APPLICATION NO.	FILING DATE	FIRST NAMED INVENTOR	ATTORNEY DOCKET NO.	CONFIRMATION NO.
10/625,937	07/24/2003	Michael Lebner	0156-2004US01	9900

Office Action Summary

DETAILED ACTION

FIG. 3

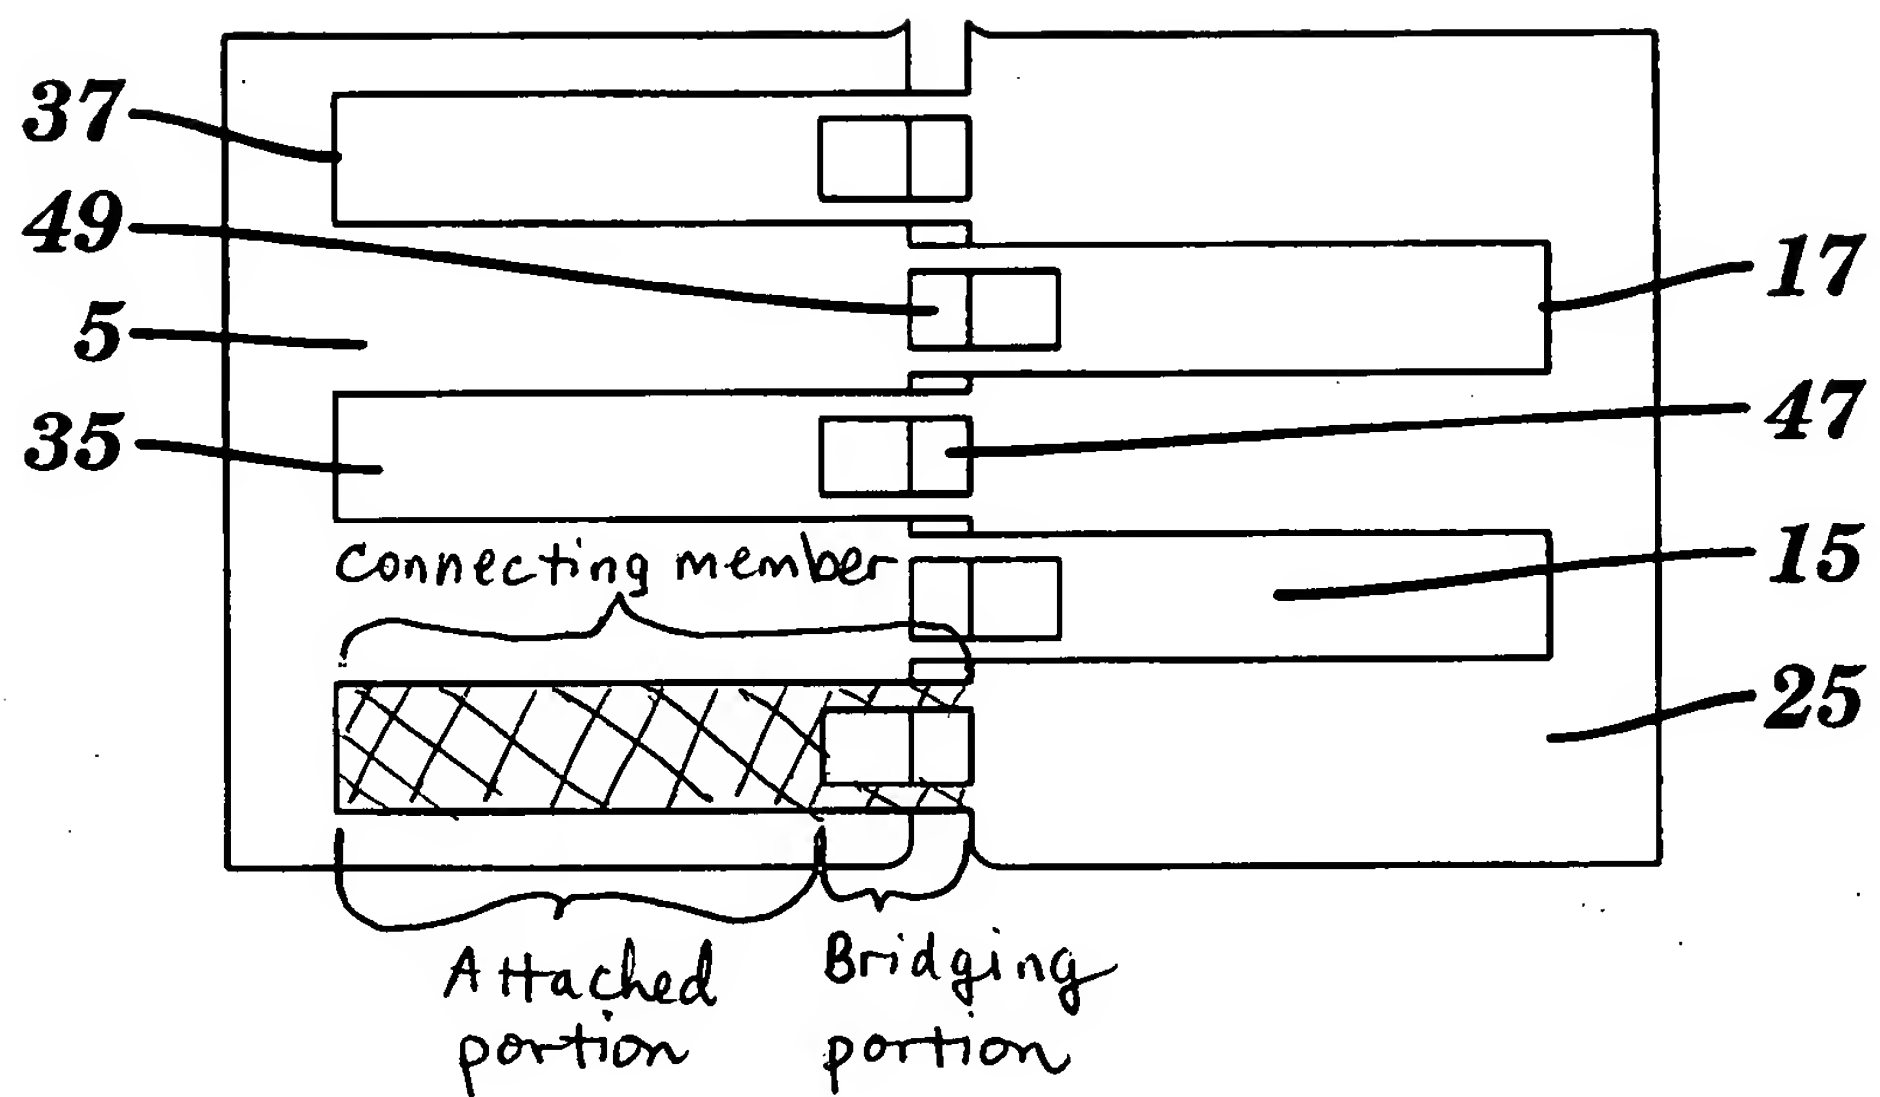
Regarding Claims 1 and 18, and with reference to Fig. 3, members (5) and (25) are first and second components. Each has adhesive on its backside for connecting to skin on either sides of a laceration [column 5, lines 51-52]. Each component (5 and 25) is attached to the anchoring member (15 and 35 respectively) by glue [column 6, lines 29-30]. Each connecting member (5 and 25—shown hatched in Attachment A) has a rectangularly shaped hole (47 and 49) cut therein, and laterally adjacent to each hole is a bridging portion, which spans over a laceration area. Said holes (47 and 49) are “positioned directly above the wound or incision to facilitate draining of exudates and application of medication” [column 6, lines 31-32]. Regarding the limitations of claim 1, sections i) and ii), Lebner teaches, “Elongated connectors 15 and 35 are attached to flat flexible components 5 and 25 by adhesive.” Lebner does not mention

specifically that more adhesive is applied to the lower surface of the *attached portion* than the *bridging portion*, however, since the lower *surface area* of the attached portion is *much larger* than the bridging portion [see Attachment A], the adhesive contained thereon will necessarily constitute the majority of the adhesive. That is, if one applied adhesive consistently on all areas of the connecting member, the volume of the adhesive on the attached portion would be larger than the volume of the adhesive on the bridging portion:

2. Regarding Claims 3, 5, 6, 20, 22, and 23, the applied prior art reference would meet claim 1 if it had merely one connecting member (37). However, Fig. 3 shows each component (5 or 25) having three connecting members (35 or 15) connected thereto. Therefore, for example, one of the *second or third connecting members* (35) could be called a “pulling element.” Such a pulling element is attached to the adjacent connecting member via the first/second component.
